Colors & Stitches Ltd.

30th July 2019

Observation : Main Production Building

Incomplete as-built drawing

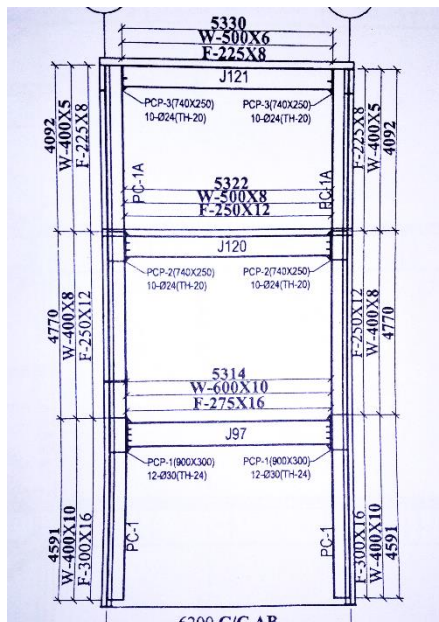
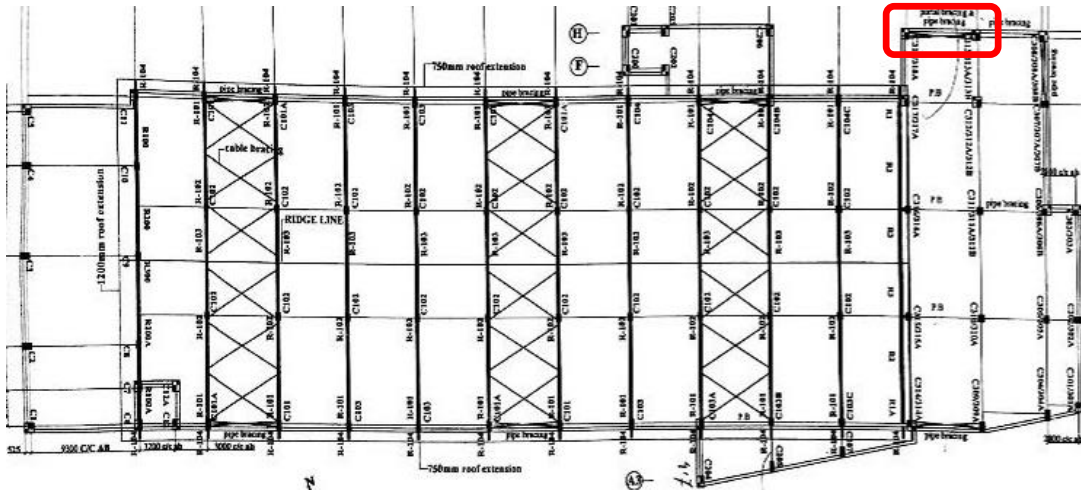
Joist on 1st floor

Portal Bracing on 1st floor

During inspection as-built drawings were available on site. But the dimensions of joists were not available. Again, locations of portal bracings were shown but dimensions were incorporated for any of the bracings. No connection details were provided for joists or bracings.

Item-01: Incomplete as-built drawing.

Bracing layout plan

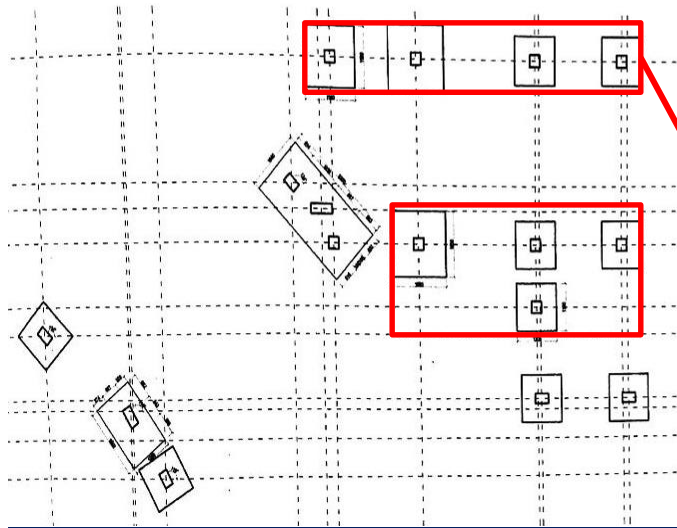
Bracing on 1st floor missing

As per provided as-built drawing, there should have a portal bracing between grid G-13 & G-14. But no portal bracing was found in that grid on site. Moreover, no connection details were provided for bracings. Factory is required to check for lateral stability and connection adequacy.

Item-02: Lateral stability and connection adequacy check.

Footing layout plan of Security Post

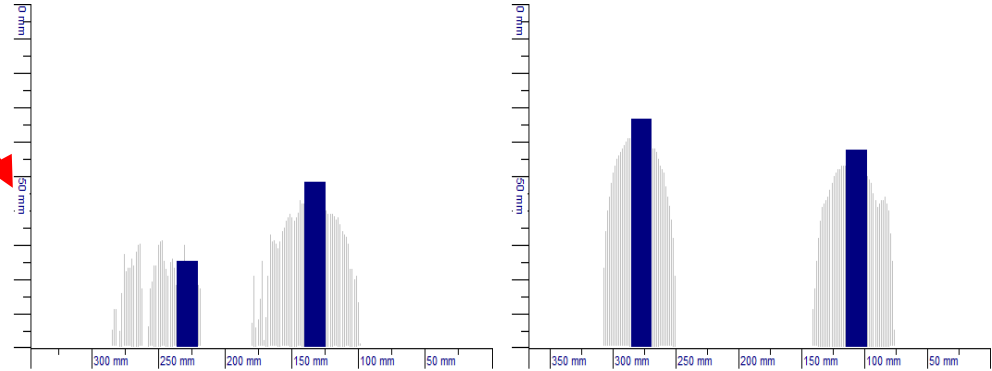
C1 type columns of supposed to have 6-16 mm diameter rebars but on site ferro scanning indicates that C1 type columns have 4 rebars.

No structural details were incorporated in the provided as-built drawings. Dimensions of slab and beams were not provided.

Factory is required to update as-built drawings of Security Post and Child Care & Medical.

Apparently non-engineered shed

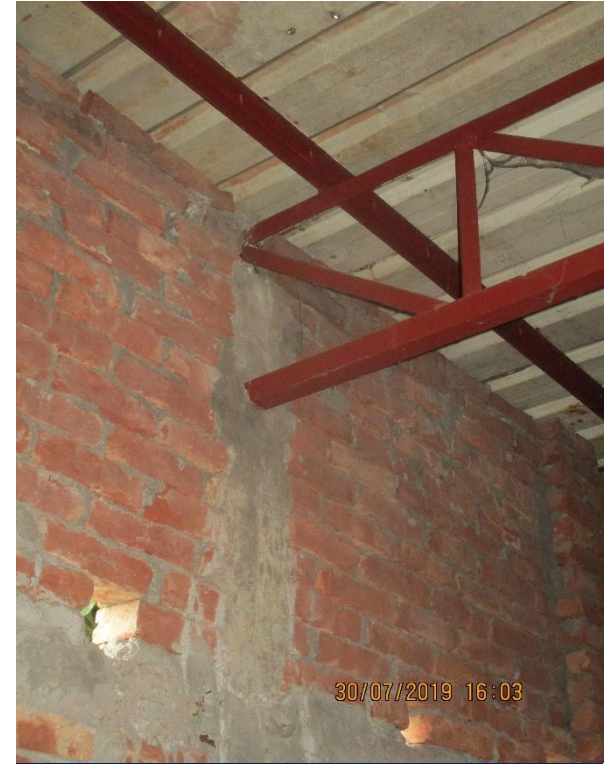
Light weight roof supported on peripheral wall

Non-engineered connection

Apparently non-engineered Wastage Shed. Roof truss is embedded in peripheral brick wall. Building engineer to check the stability of the lightweight roof structure against lateral loading and if inadequate then replace the structure with an engineered one.

7	Apparently non-engineered shed. (Wastage Shed)	Carry out remedial works resulting from engineering assessment if necessary.	6-months
